What has Changed?

SNIA Emerald™ Power Efficiency Measurement Specification V2.1.1 to V3.0.2

July 11, 2018

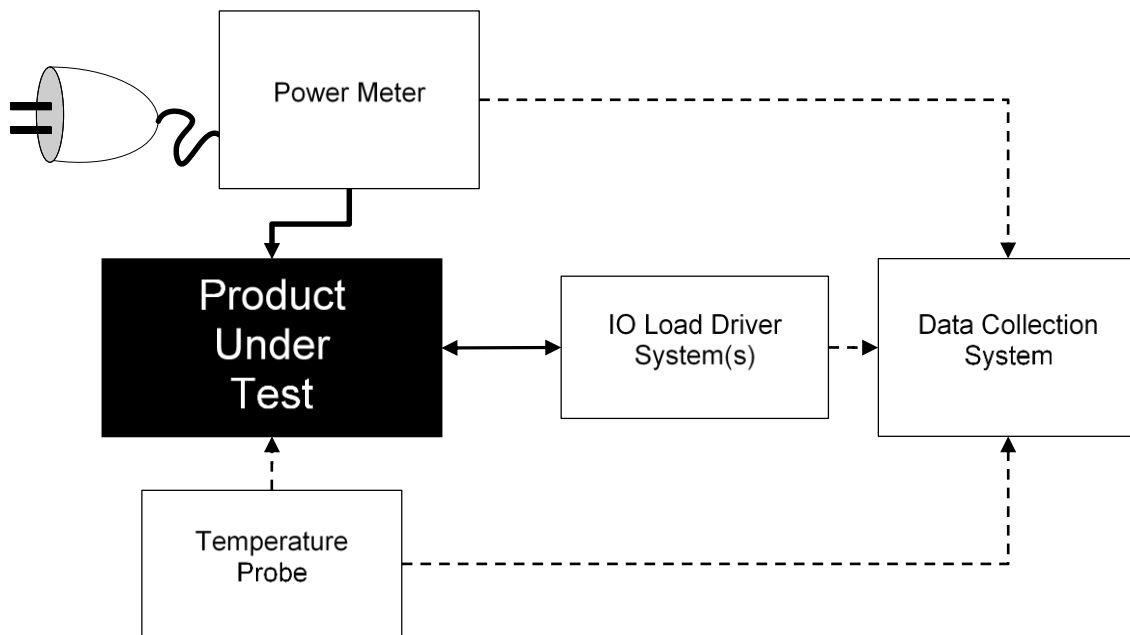
Figure 1 is an improved sample configuration for **block**.

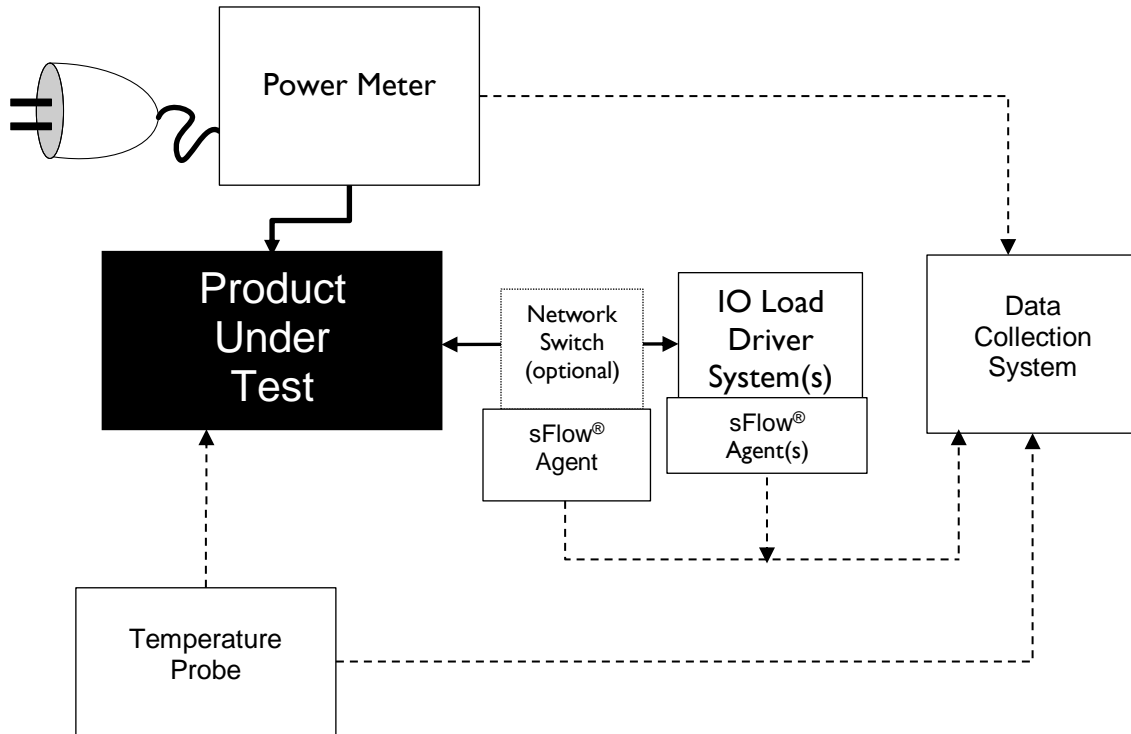
Figure 2 adds a diagram that depicts the connectivity for a file access storage system. Please observe that the key difference with block is the sFlow® connection.
